Product Change Notice (PCN)

PCN Number: PCN-0451070R-02

Product(s) Affected: PJ-028-SMT-TR

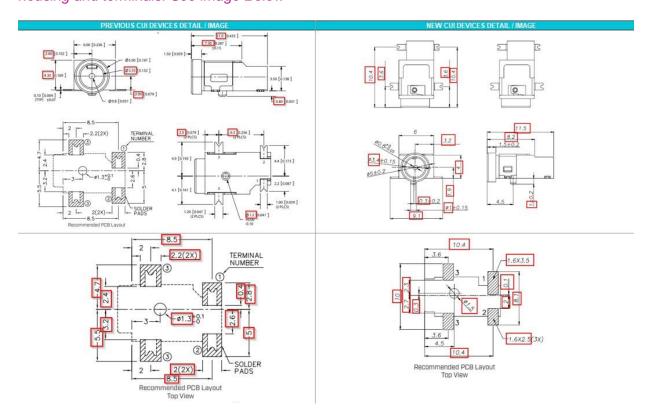
Description of Change: Minor Housing and footprint differences. Material Change on the housing and terminals. See image Below

MATERIAL	PLATING
center pin	brass	silver
terminal 1	brass	silver
terminal 2	copper alloy	silver
terminal 3	copper alloy	silver
plastic	PA10T

DESCRIPTION	MATERIAL	PLATING/COLOR
center pin	brass	gold
terminal 1	brass t=0.20	gold
terminal 2	phosphor bronze t=0.25	gold
terminal 3	phosphor bronze t=0.20	gold
housing	PA9T [UL94V-0]	black
